## Nuneaton and Bedworth Area Committee 28th September 2005

### Ribbonfields, Nuneaton - Proposed Prohibition of Waiting Restrictions

# Report of the Director of Planning, Transport and Economic Strategy

# QA Form 19 02/96 APPENDIX B OF AGENDA NO.

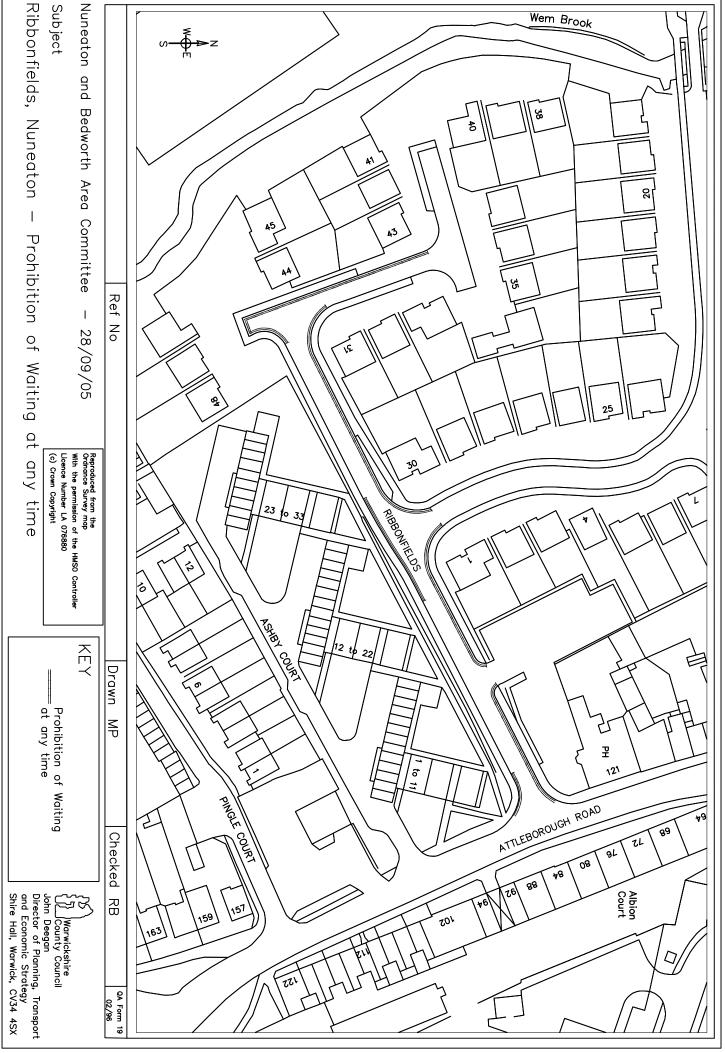
- 2.3 The response from the resident made reference to support for the earlier proposals for restrictions on both sides of the access road. However, it went on to suggest an extension of the double yellow lines on the south side fronting No. 48 to give further protection on the approach to the cul-de-sac junction. A further consultation was carried out in August on this suggestion which is shown on the plan in **Appendix B.**

- 2.4 Two further responses have been received from residents. One expresses full support for all of the latest proposals. The other is signed by four Ribbonfields residents and raises concern that the extension of double yellow lines across the frontage of No 48 will result in more vehicles being forced to park in other areas of the estate.

3.1 It has always been accepted that the introduction of double yellow lines on any length of the south side of the access road could result in vehicles being displaced into other areas of the estate. However, the view is that, even with the restrictions shown on the plan in **Appendix A**, the amount of on-street parking available in the access road will be sufficient to meet the demand at most times. The majority of residents would appear to support the restrictions shown on the plan in **Appendix A** but, there is some merit in the suggestion for additional protection on the approach to the cul-de-sac. This would give drivers overtaking any parked vehicles the opportunity to return to the nearside of the road before

turning left or right. There is a risk with this of further displacement but this would be just one vehicle.

3.2 In the circumstances it is recommended that the restrictions shown on the plan in **Appendix B** be implemented.
